## Official Recall Notification U.S. Federal Boating Safety Act

# Replacement of Polymer Steering Fluid Cooler on Mercury MerCruiser Sterndrive Models

Steering cooler with polymer housing—replace

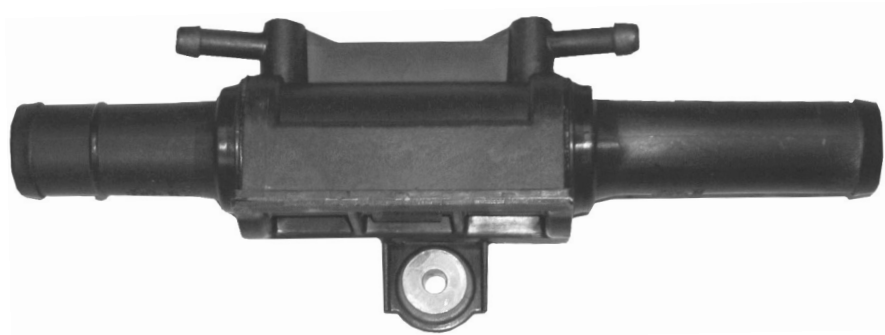
It is possible for the polymer steering cooler to break, allowing seawater to be discharged into the boat, causing the engine to overheat, and putting the boat at risk for swamping or sinking.

Replace every polymer steering fluid cooler with the appropriate copper steering cooler at the earliest possible time.

**Steering cooler with copper housing—do not replace**

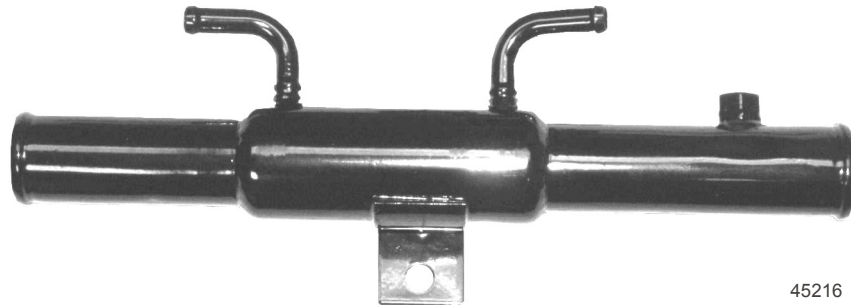
- Engines without a steering cooler
- Engines equipped with a copper steering cooler
